Product Change Notice - Announcement

PCN no.: P25-2015-001
Date: 2015-04-27
PCN Type: Information
Subject: EGO[®] Radiant Heating Elements - omission of P1 tab
Reference: Product Management - Tilo Fucik

4. Identification of change

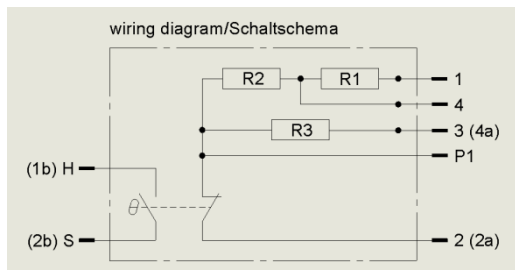
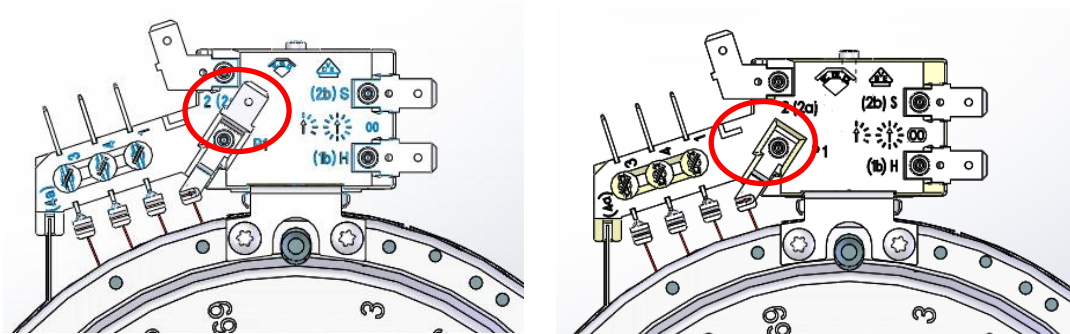
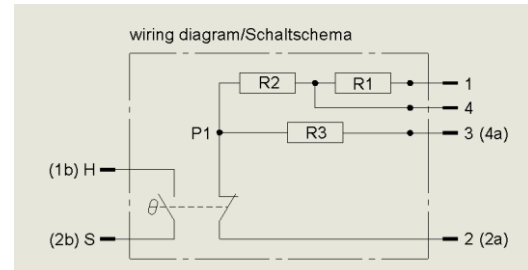
Continuous improvement of E.G.O.'s products and market observation has given the proof that the P1 tab on the below-mentioned EGO[®] types is not needed. Actually, the P1 terminal could even lead to failures or miswiring during the assembly of the heater in the hob.

The function of the limiter remains unchanged.

This change is made in order to help to increase the product quality within the hob production.

Since this change is related to the P1 tab terminal only a sample procedure is not planned.

old version

new version
